RIO-2 Visual Impact Mitigation Re-opener Draft Determination: National Grid Electricity Transmission's Cotswolds VIP Project

Publication date:	01 April 2026
Response deadline:	28 April 2026
Contact:	Evan Alaa
Team:	Network Price Controls – Small & Medium Sized Projects
Email:	ReopenerConsultations@ofgem.gov.uk

Figure 2: Cotswolds National Landscape subsection ZF.2

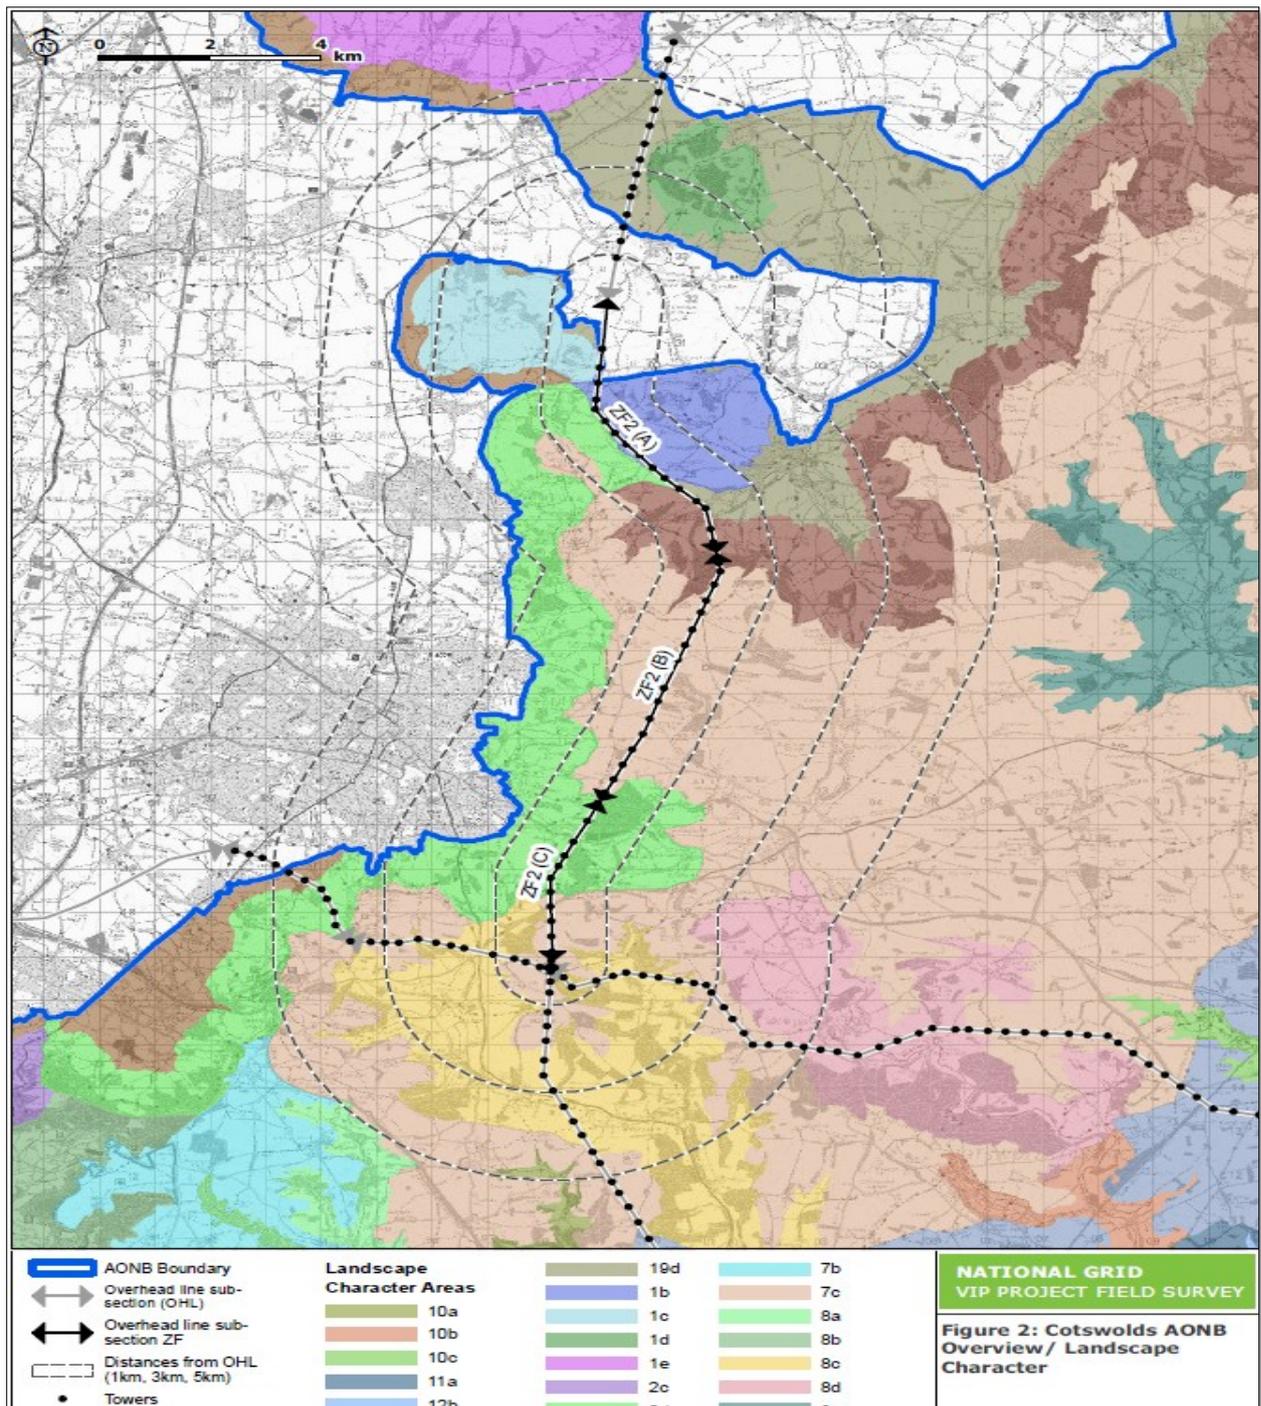
- 2.9 It was recognised by NGET that undergrounding the entire length of the Cotswolds ZF.2 subsection (17km) would involve excessive cost (exceeding the overall £465m RIIO-ET2 funding cap for RIIO-ET2) and would therefore not be affordable for consumers. In order to investigate what could be achieved for lower costs, within the funding cap, NGET commissioned a more detailed Cotswolds Appraisal study in 2020. The study suggested splitting the ZF.2 section into three smaller subsections for appraisal purposes and concluded that undergrounding subsection ZF.2(B) would deliver the greatest visual improvement (see **Figure 2**).¹⁶

- 2.10 The ZF.2(B) sub-section is approximately 7.4km long and forms part of the existing 400kV Feckenham – Walham and Feckenham – Minety double circuit overhead electricity transmission line. The subsection NGET proposes to underground is approximately 6% of the 110.13km of transmission line that runs through the boundaries of Cotswolds National Landscape and would mean the removal of 16 of the total 288 pylons within the designated area.

- 3.7 We have assessed NGET's application with the above considerations in mind. We agree that NGET is correct to reject options that do not deliver the required tCSNP driven system upgrades (Option 1 and Option 5). It is also correct in rejecting Option 6 as the benefits delivered would not be commensurate with the cost that consumers would need to pay.

- 3.8 Option 4 clearly delivers no additional benefits, either system benefits or visual impact mitigation benefits, over Option 3 (NGET's preferred option), but would be at a significantly higher cost. It is therefore not clear to us why NGET took this option forward for further consideration, as the outcome of any comparative assessment is immediately evident.

- 3.10 Both Option 2 and Option 3 provide the same system benefits. We therefore do not consider that, independent of any visual impact mitigation benefits and associated costs, that the system benefits themselves justify the investment required to underground the existing infrastructure as proposed in Option 3.

- 3.14 Given that Option 2 delivers the required system benefits, we do not think that it would be appropriate to allow consumer funding for an additional estimated £177.56m for the visual amenity benefits associated with the removal of 16 of the 288 pylons, and undergrounding of 7.4km of the total 110.13km overhead line which runs through the Cotswolds National Landscape. We especially do not think that this is good value for money for consumer funding, including when considered within the broader energy and affordability context.

- 3.15 Our assessment therefore is that, of the two realistic options considered, Option 2 is the better option as it delivers the same system benefits but at significantly lower cost.

Act 1989. For the reasons explained above, our Draft Determination is to reject NGET's application.
